Planning & Zoning
Commission
Agenda

Site Plan for Mighty 8th Air Force Museum Phase II Expansion.

Re: National Museum of the Mighty 8th Air Force - Phase 2 - Specific Development Plans

Plans entitled National Museum of the Mighty 8th Air Force - Phase 2 - sheets C1-C14, L1, F1, and E1.0 dated 4/18/24.

CIVIL UTILITY PLAN

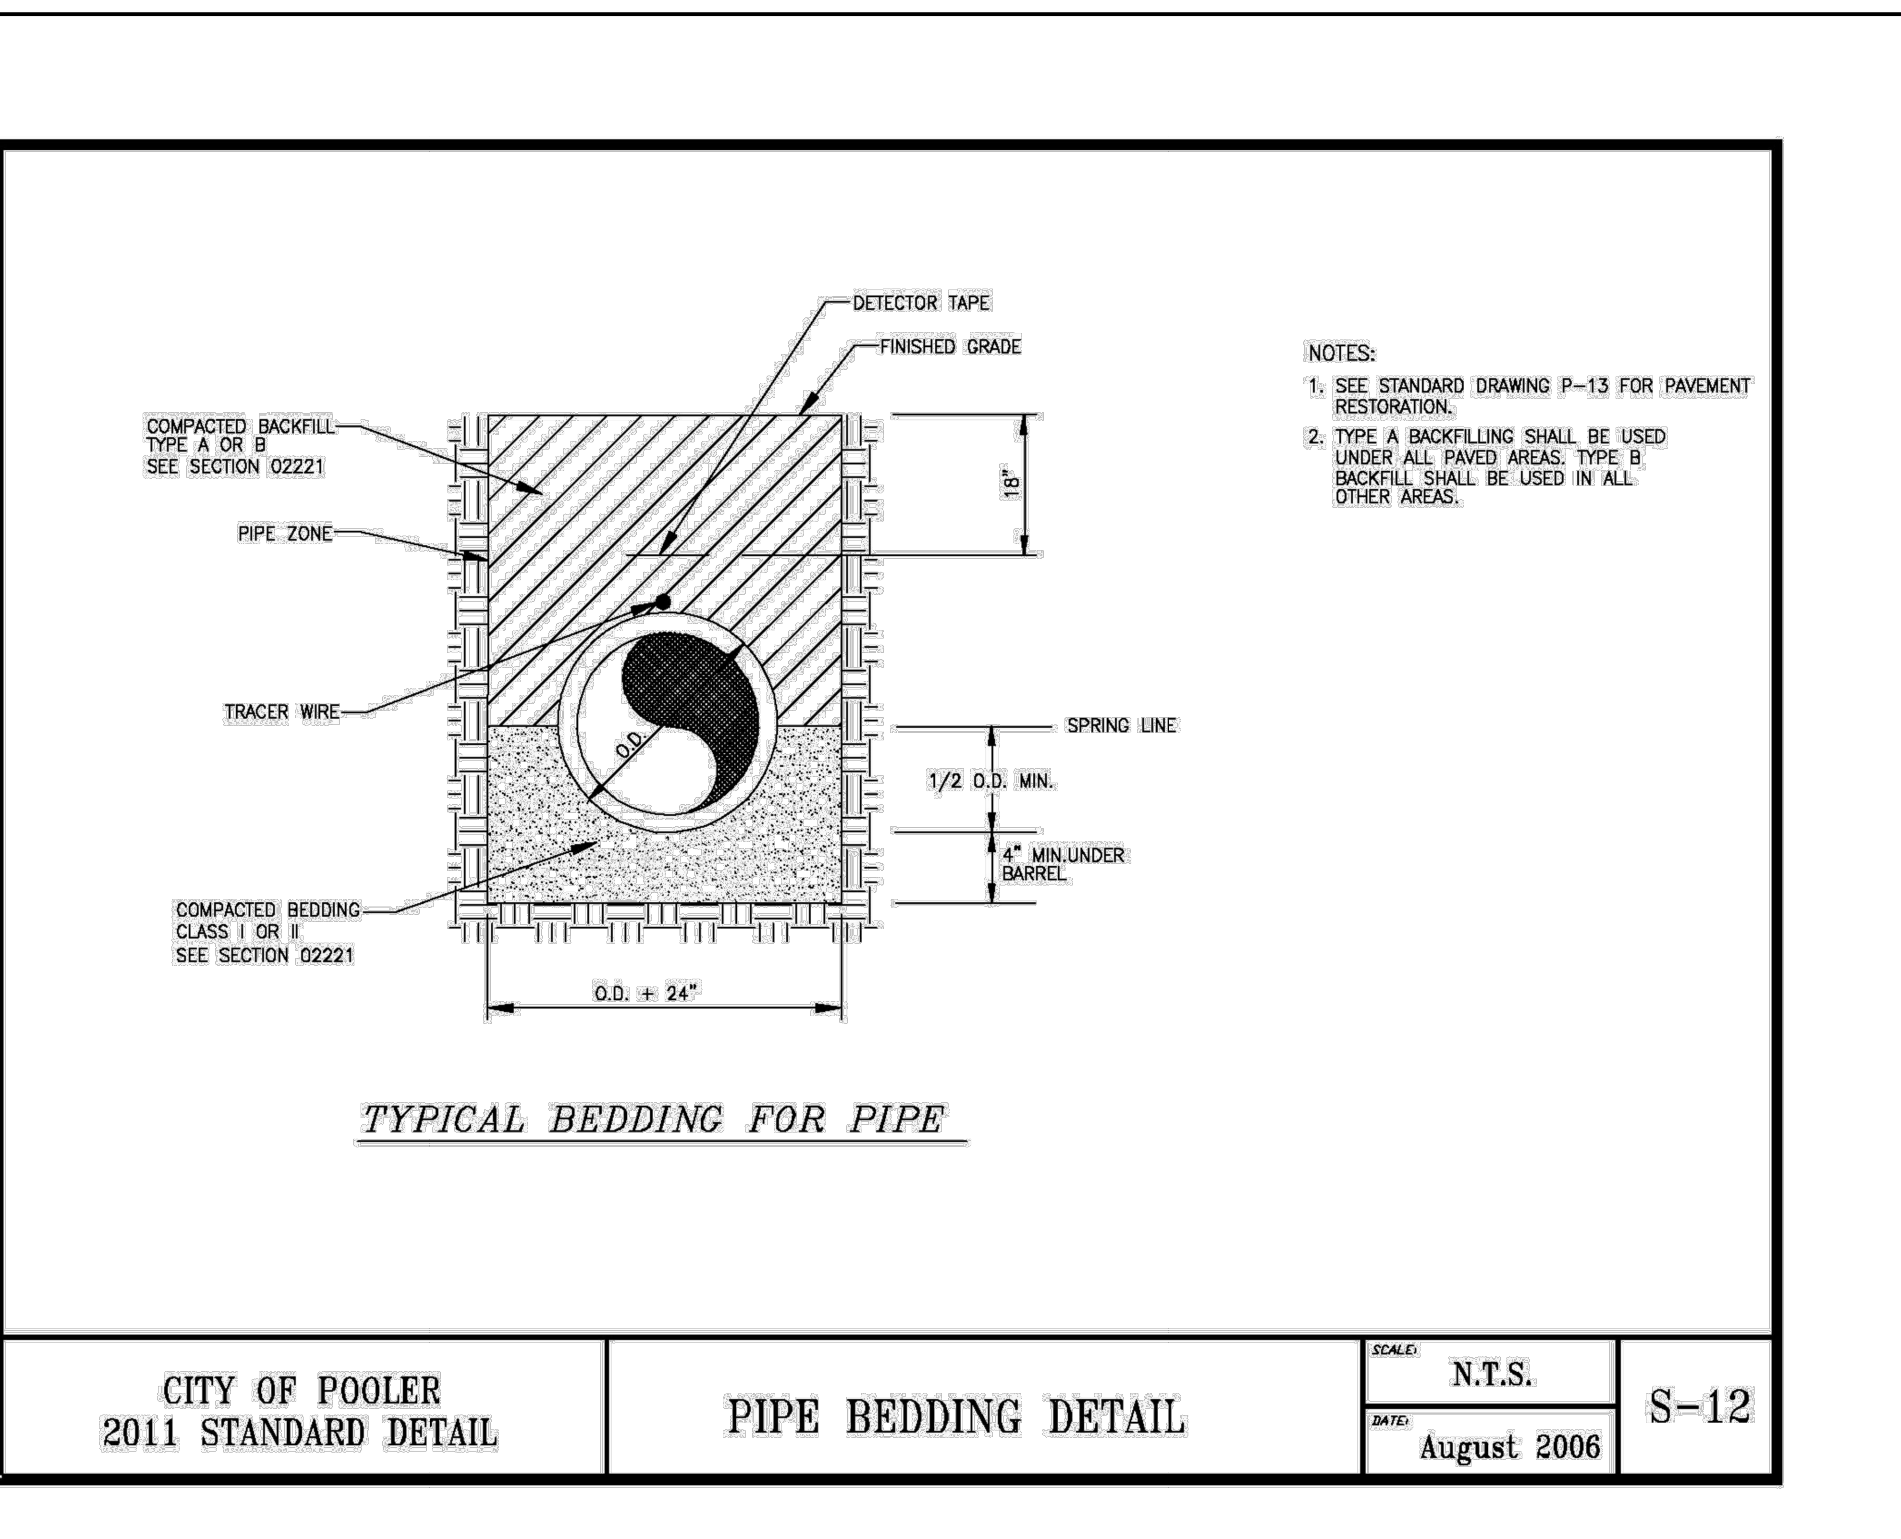
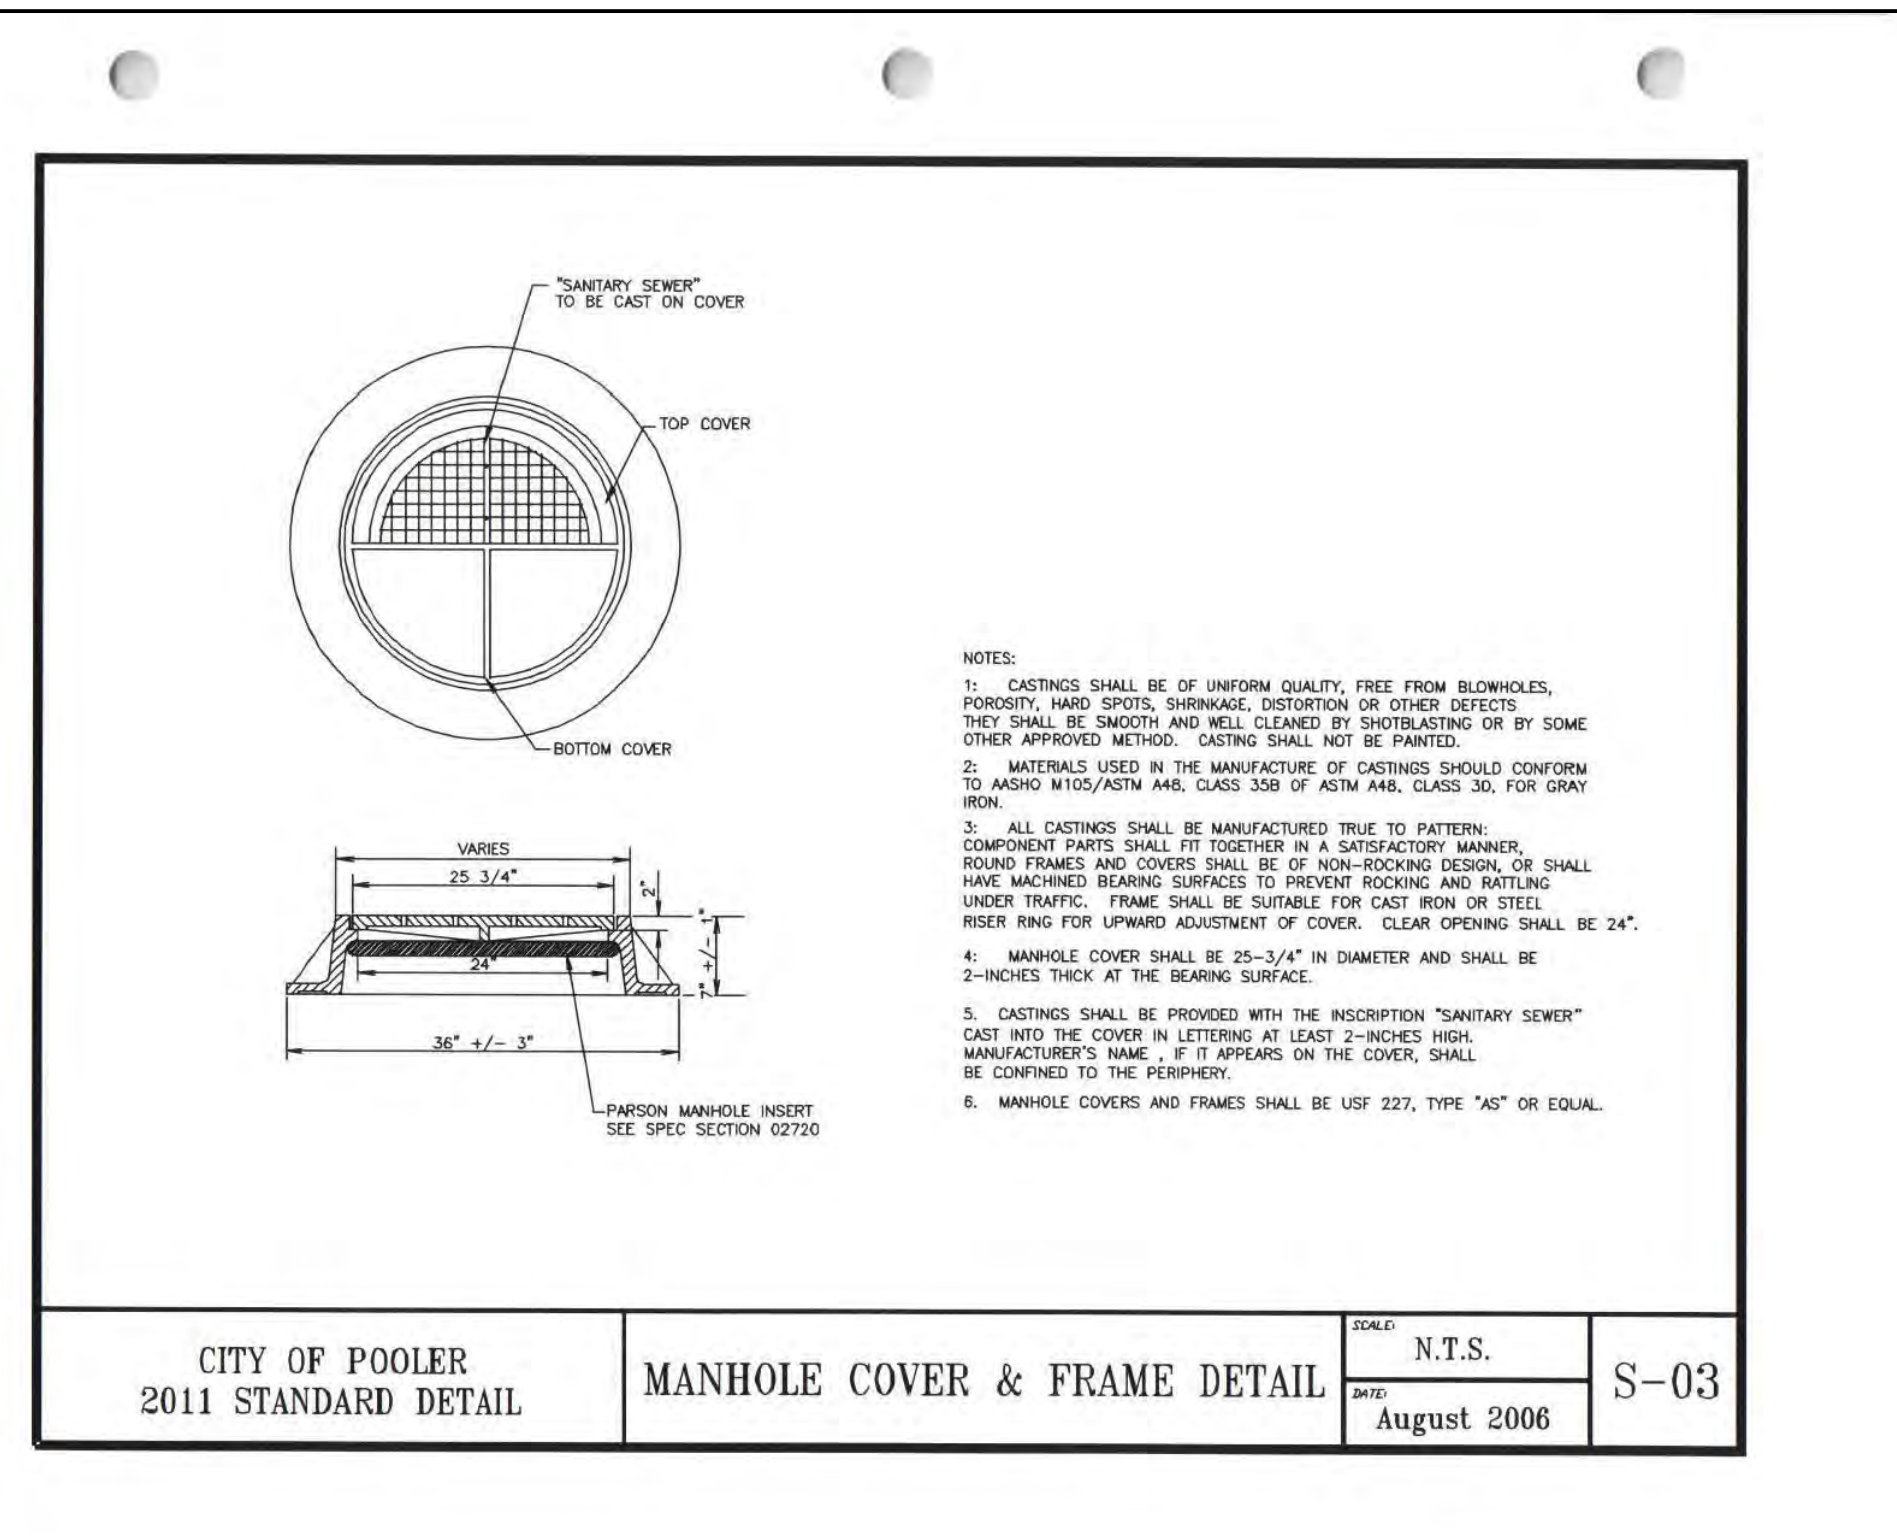
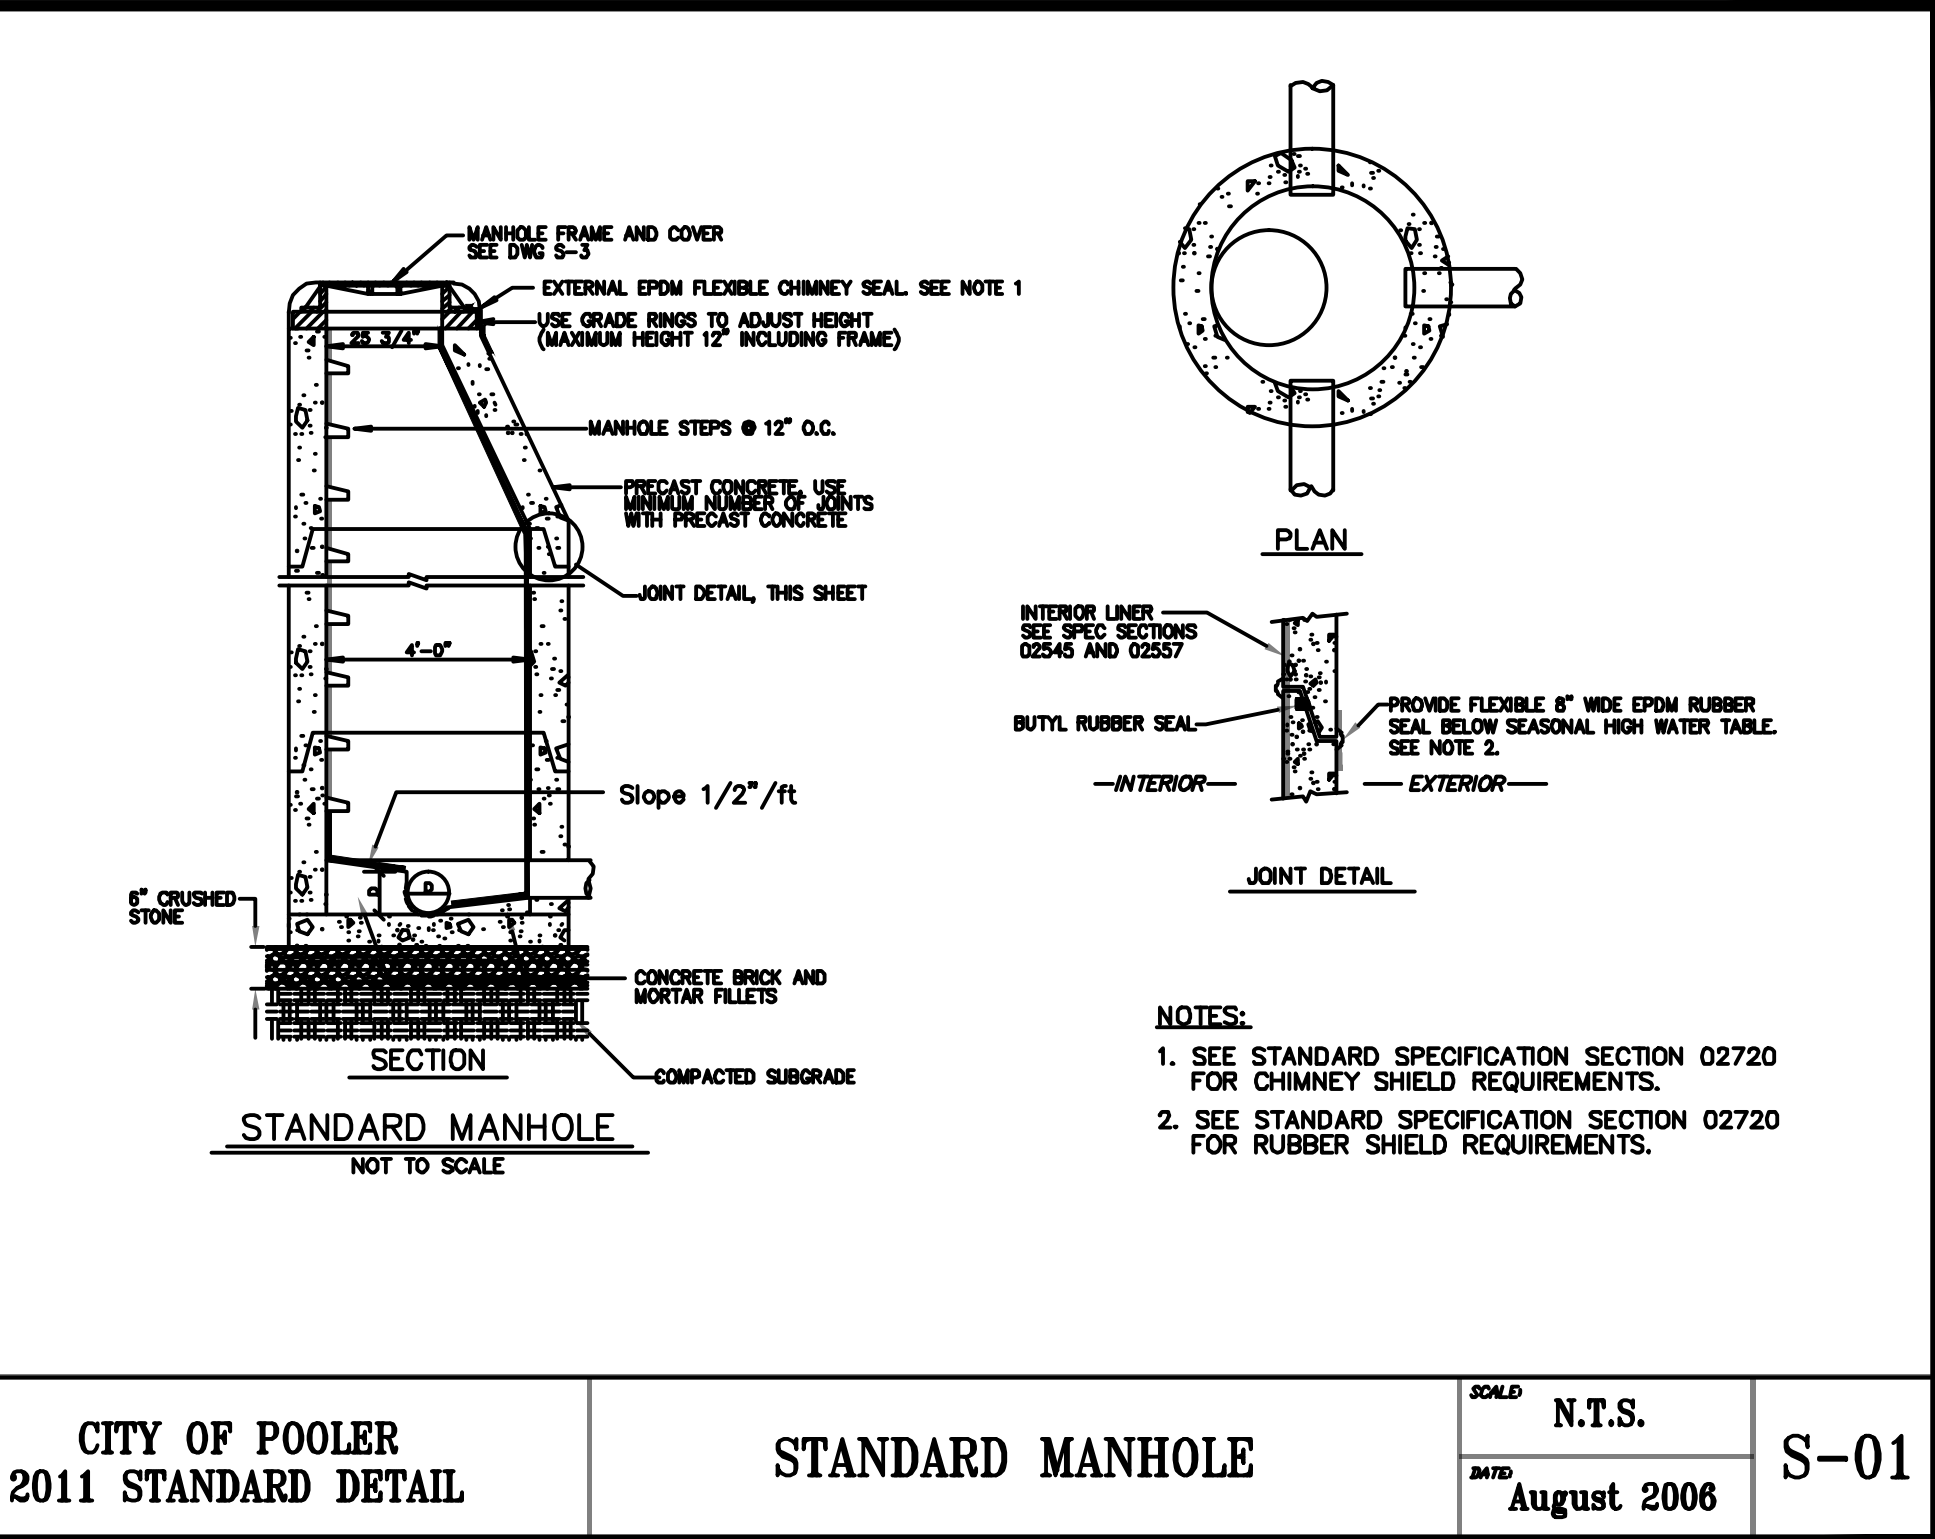
16. Per City of Pooler Water Department:
- a. Plans do not clearly show how building is tied into the existing water.
We have added notation where the existing potable water and fire lines enter the building on the utility plan (C6).
 - b. Plans do not show any type of irrigation. **Staff will temporarily irrigate plantings from a hose bib during the plant establishment period. No permanent system exists or is proposed.**
17. There must be a sampling manhole (min 18 inch diameter) just downstream of the grease trap (upstream of any other domestic connection). **A manhole has been added per request just downstream of the grease trap.**
